DESIGN RF	DRAWN BY RF	DART AEROSPACE LTD HAWKESBURY, ONTARIO, CANADA	
CHECKED <i>[Signature]</i>	APPROVED <i>[Signature]</i>	DRAWING NO. DSI 9300	REV. B SHEET 1 OF 6
DATE 05.08.12		TITLE SIMPLEX TANK STEP SCALE NTS	
A	05.05.05	NEW ISSUE	
B	05.08.12	ADD STRUTS IF TANK REMOVED

DART SERVICE INSTRUCTION

TO AMEND INSTALLATION INSTRUCTIONS IIN-D205-633 REV. A

THE PURPOSE OF THIS SERVICE INSTRUCTION IS TO ADD THE D205-633-021/-022/-023/-024/-025/-026 STEPS TO ADDRESS COMPATABILITY WITH THE SIMPLEX MODEL 304 FIRE ATTACK TANK. D205-633-021/-022 ARE IDENTICAL TO D205-633-011, EXCEPT AS SHOWN HERE. D205-633-023/-024 ARE IDENTICAL TO D205-633-013, EXCEPT AS SHOWN HERE. D205-633-025/-026 ARE IDENTICAL TO D205-633-015, EXCEPT AS SHOWN HERE.

DETAIL S
NOT TO SCALE

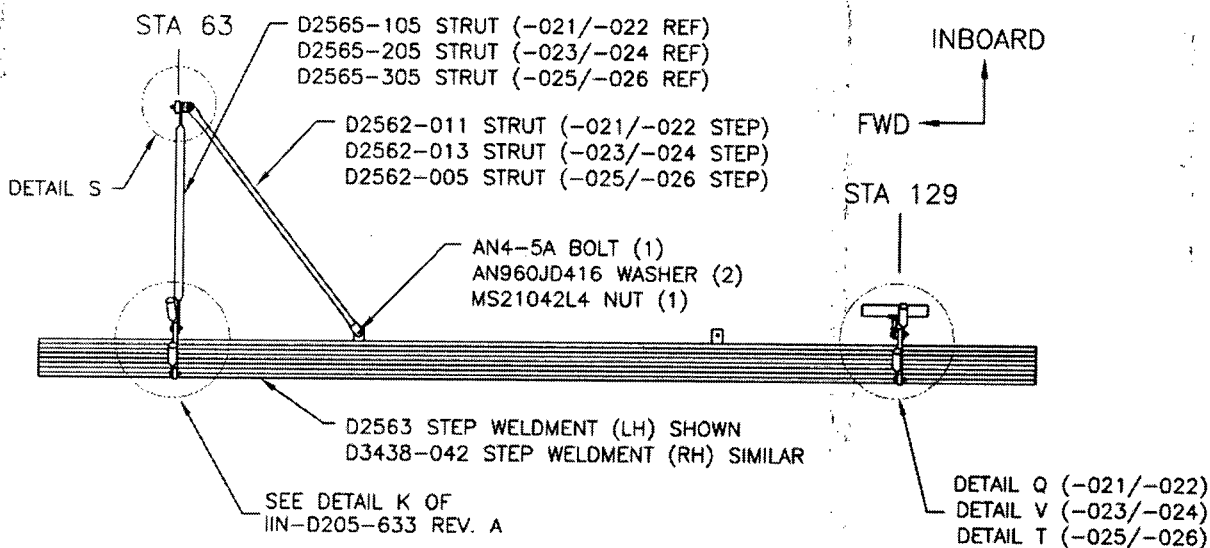
INSTALL D205-633-021/-022 AS PER THE D205-633-011 STEP OF INSTALLATION INSTRUCTIONS IIN-D205-633 REV.A, EXCEPT REPLACE D2565-111 STRUT WITH THE D3437-041 AFT STRUT ASS'Y, REMOVE D2562-001 STRUT, INSTALL D2562-011 STRUT AS SHOWN.

VIEW X-X
NOT TO SCALE

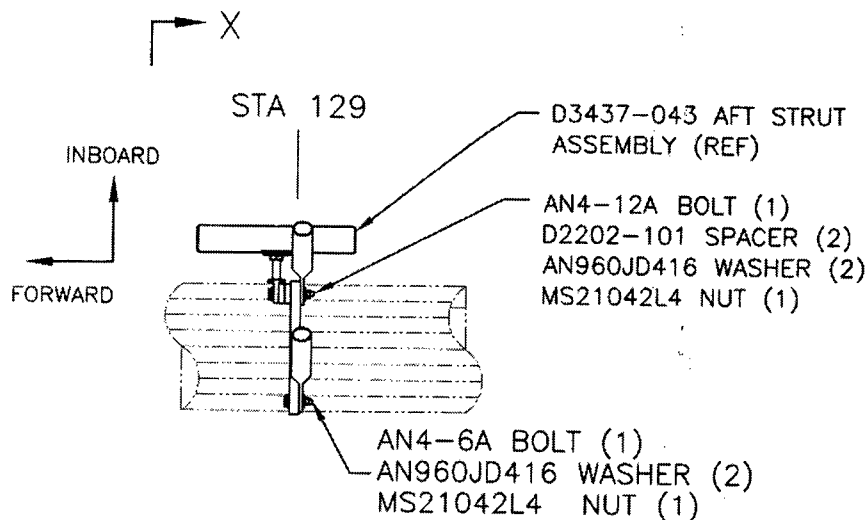
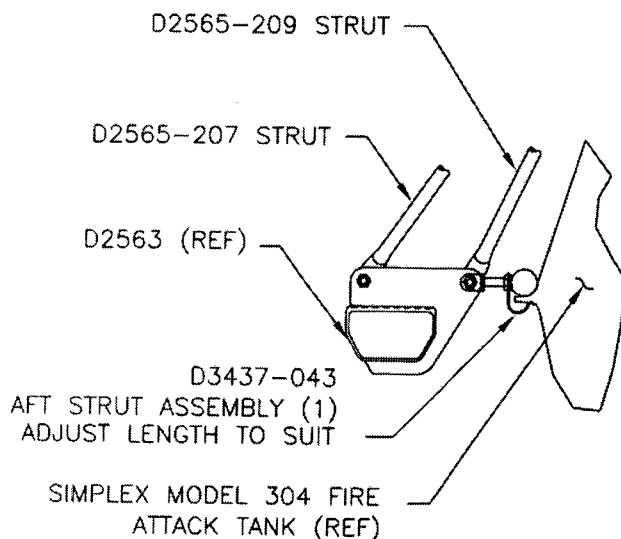
INSTALL D205-633-023/-024 AS PER THE D205-633-013 STEP OF INSTALLATION INSTRUCTIONS IIN-D205-633 REV.A, EXCEPT REPLACE D2565-211 STRUT WITH THE D3437-043 AFT STRUT ASS'Y, REMOVE D2562-003 STRUT, INSTALL D2562-013 STRUT AS SHOWN.

VIEW U-U
NOT TO SCALE

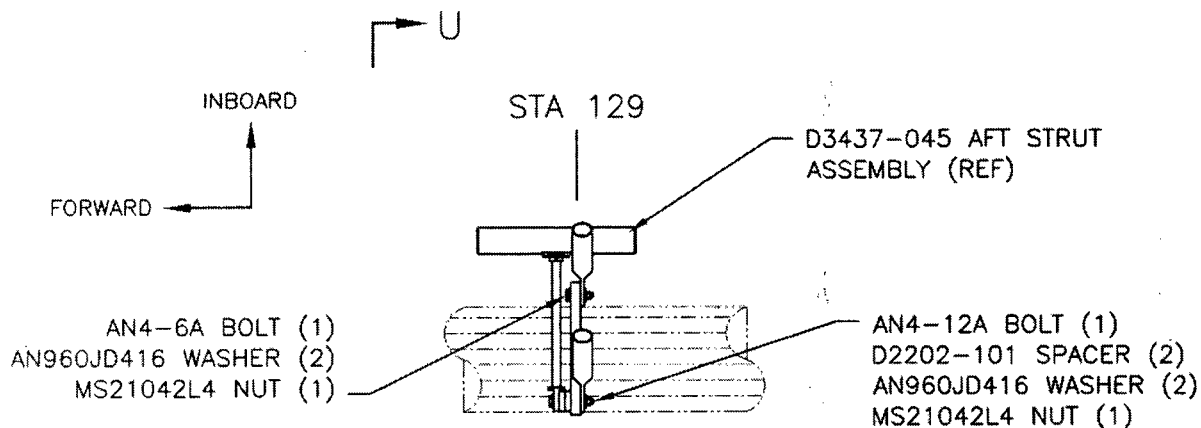
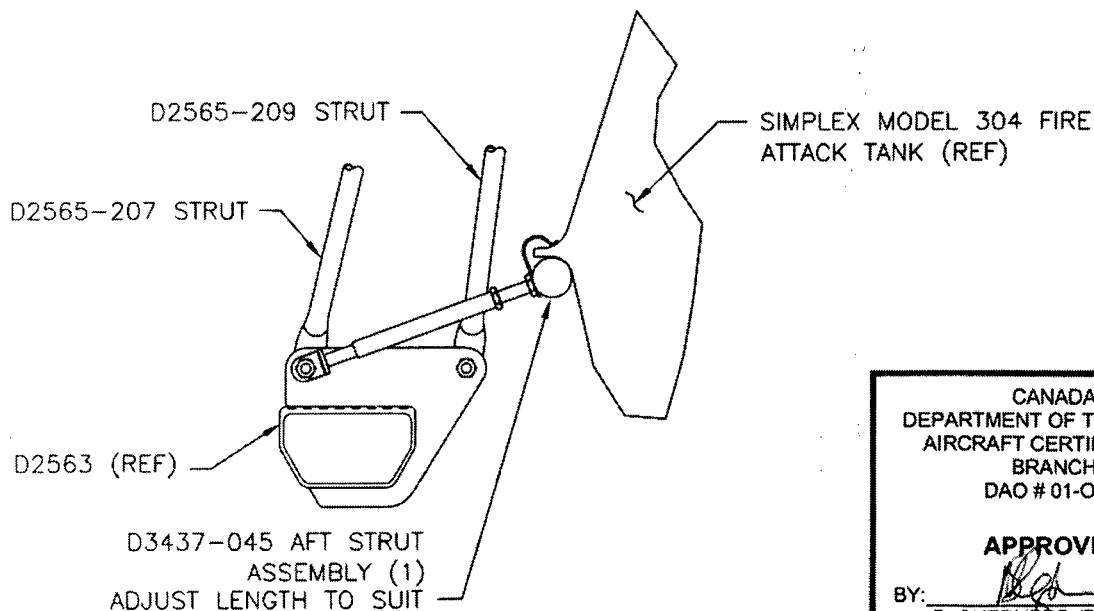
INSTALL D205-633-025/-026 AS PER THE D205-633-015 STEP OF INSTALLATION INSTRUCTIONS IIN-D205-633 REV.A, EXCEPT REPLACE D3165-1 SUPPORT ARM WITH THE D3437-045 AFT STRUT ASS'Y AS SHOWN.
